PLANNING AND DEVELOPMENT COUNCIL MEETING

FROM:	Planning Services Department						
DATE:	April 5, 2019						
SUBJECT:	Update Report, Oakville Green Development Inc., Part of Lot 25, Concession 1, NDS, File No. Z.1325.07, 24T-18006/1325						
LOCATION: WARD:	North of Dundas Street, East of Third Line 7	Page 1

Figure 1: Proposed land exchange from town to Owner (orange) and vice versa (blue).

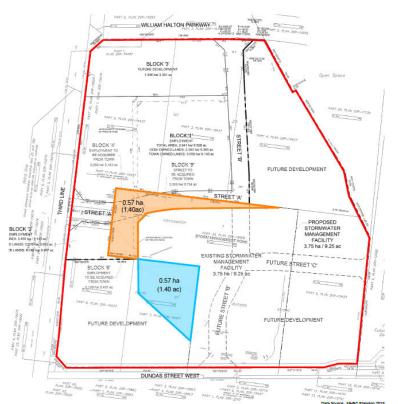
In general, the supporting engineering submission outlines how the proposed site development would be serviced, graded, and the proposed alterations to the Glen Oak Stormwater Management Pond. Since the Statutory Public Meeting on February 11th, 2019, the Owner agreed to exchange and equal amount of land (0.57 ha (1.4 acres)) to reshape the Glen Oak Stormwater Management Pond. However, it is noted that part of the lands proposed to be provided to Oakville Green consisting of 'Street A' would be rededicated back to the town as a public road.

Staff are satisfied that all previous comments identified in a letter to the applicant dated January 25th, 2019 which were required to be addressed prior to draft plan approval, have been addressed. In general, staff are satisfied that the proposed alterations to the Glen Oak Stormwater Management Pond will provide an equal or greater volume than the currently constructed pond and that the design of the Pond has been sufficiently advanced to support the Phase 1 development, subject to conditions which could be satisfied through draft plan approval of the subdivision. Staff comments are provided in 'Appendix B'.

It is anticipated that the remaining comments could be addressed as conditions of draft plan approval and in a future Environmental Implementation Report / Functional Servicing Study Addendum.

The Owner would be responsible for all costs associated with the proposed alterations to the Glen Oak Stormwater Management Pond.
